Referral 5: Chadstone Activity Centre

Activity Centres Standing Advisory Committee Report

12 November 2024

Figure 3 Proposed change to catchment boundary

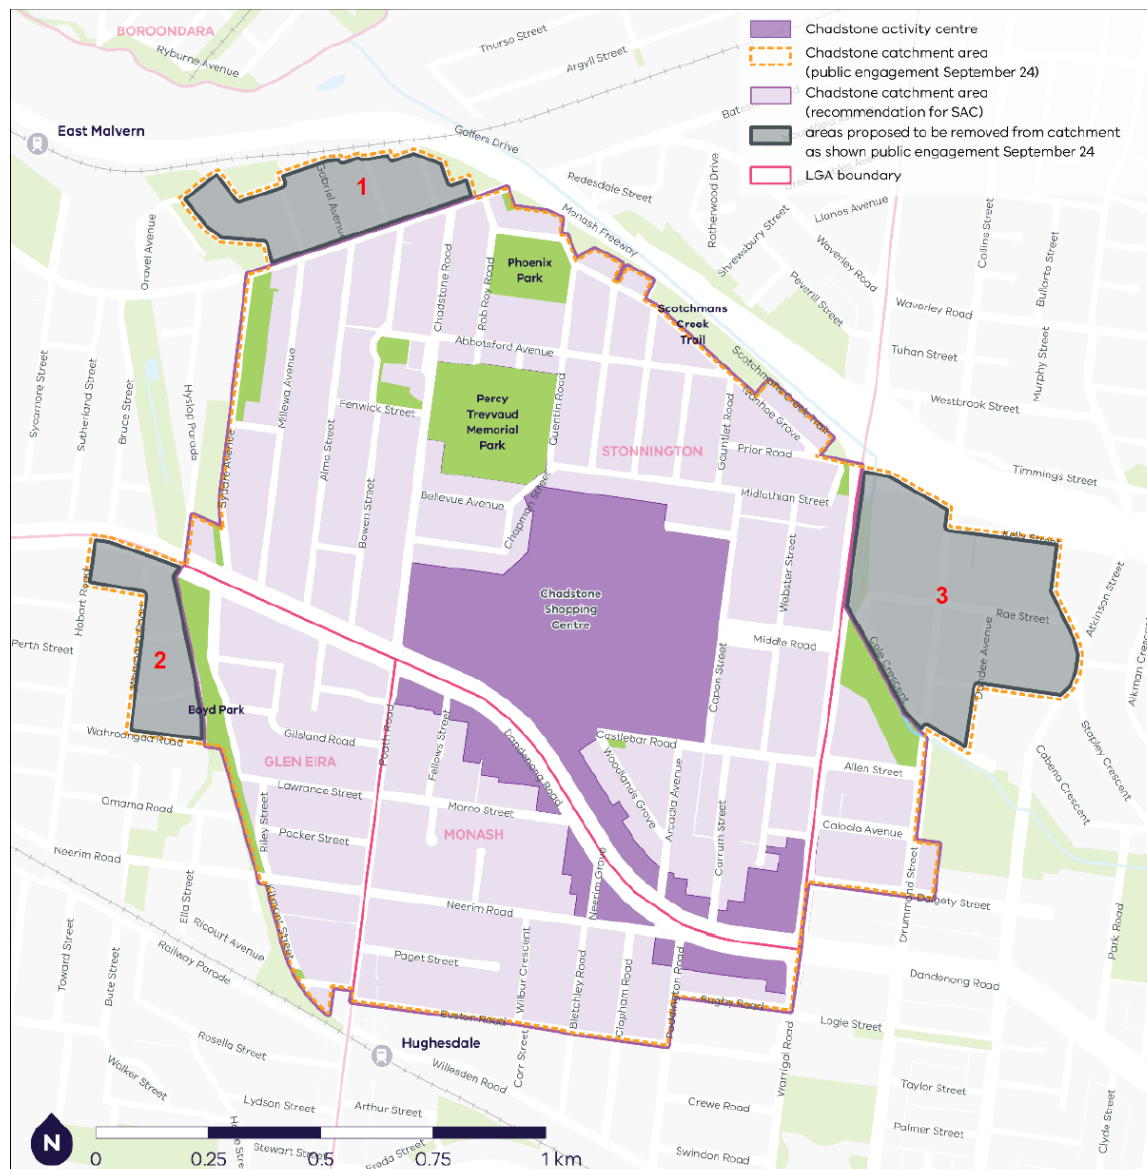
The VPA proposes to change the catchment boundary to exclude the grey shaded areas in Figure 2 for the following reasons:

- Area 1 – distance to core commercial amenities and services of the Activity Centre
- Area 2 – distance to core commercial amenities and services, and the physical barrier of Boyd Park
- Area 3 – the barriers presented by Scotchman's Creek and the Monash Freeway.

Monash also submitted the catchment area should not be included in the Activity Centre Plan, suggesting a distance of 800 metres from the edge of the shopping centre is excessive. It specifically recommended removal of Area 3 on Figure 3, as it includes heritage areas and is separated from the Activity Centre by a significant physical barrier (Warrigal Road).

Glen Eira submitted the area west of Boyd Park (Area 2 on Figure 3) should be removed.

- exclude Areas 1, 2 and 3 identified in Figure 3 as they are too distant from the services within the Activity Centre that serve day to day needs (and are separated by physical barriers)
- exclude areas south of Dandenong Road and east of Warrigal Road, as these major roads present significant physical barriers to pedestrian access to the shopping centre
- measure the 800 metres walkable distance from the commercial services within the centre that serve day to day needs (not the outer edges of the carparks)
- exclude all Fringe Precinct areas and the Percy Treyvaud Memorial Park from the area from which the 800 metres is measured.
